**SAVE BUNGENDORE PARK INC.**

**RESPONSE TO SOCIAL IMPACT STATEMENT DATED 7 SEPTEMBER 2021 AND ADDENDUM**

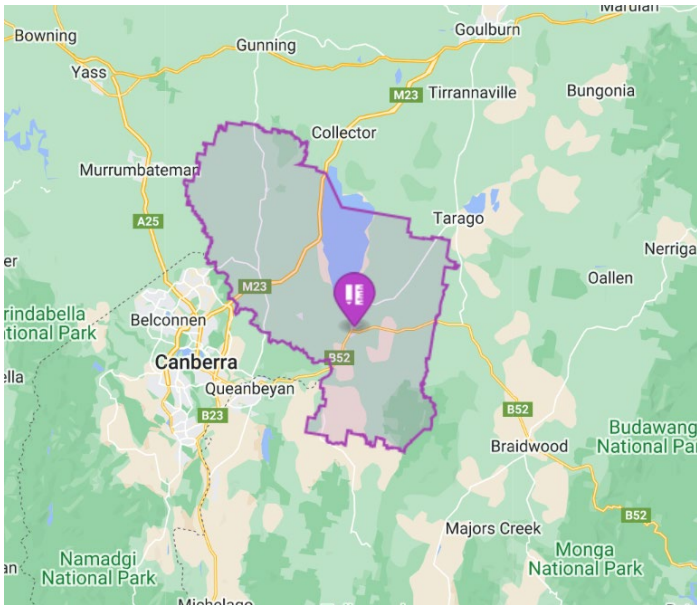
7.	Additional impact – temporary school construction	<p>The choice of site and the planning complexities have caused major delays to the planning and approval process. Consequently, the Department of Education is proposing that Bungendore High School will open for years 7 and 8 in 2023, in demountable classrooms. It has identified the Bungendore Public School grounds as the “preferred” location for these classrooms.</p> <p>Approximately 23 demountable buildings will be installed on the playground of the Bungendore Public School for the initial cohort.</p> <p>Installing these within the grounds of Bungendore Public School will have a significant negative impact on students attending both schools. It will cause massive disruption and reduction in play space for Bungendore Public School, as well as a less than ideal facility for Bungendore High School.</p> <p>Mrs Overall said in a recent radio interview that this temporary facility would be in place for a maximum of two terms, while construction of a permanent facility on Bungendore Park was completed.</p> <p>However, given the extremely prolonged planning process and ongoing challenges, and the near certainty of legal action if development consent is granted, the temporary facility in the grounds of Bungendore Public School is likely to remain indefinitely and require expansion as additional cohorts join in 2024 and 2025.</p> <p>Rejection of this development application will require the Applicant to commence planning on a more feasible and less controversial site, offering certainty as to timing which will be strongly positive for both schools. By way of illustration, the SSDA for the nearby Jerrabomberra High School – on a greenfield, uncontroversial site – went on public exhibition in November 2021, it was approved in July 2022 and construction started soon after.</p> <p>This SSDA went on exhibition in September 2021 and if development consent is granted, it is likely to be further 1-2 years before legal avenues are exhausted and construction of a project can commence. It is likely to be a further 12-18 months before a permanent school can open and several months after that before demountables can be removed and the grounds of Bungendore Public School remediated. It may be 2026 before Bungendore Public School is able to resume normal operations.</p> <p>The SIA must address the impact of this on both the Primary School and the proposed High School. This impact could be significantly mitigated if this DA is withdrawn and the Applicant acquires a suitable site for this project.</p>
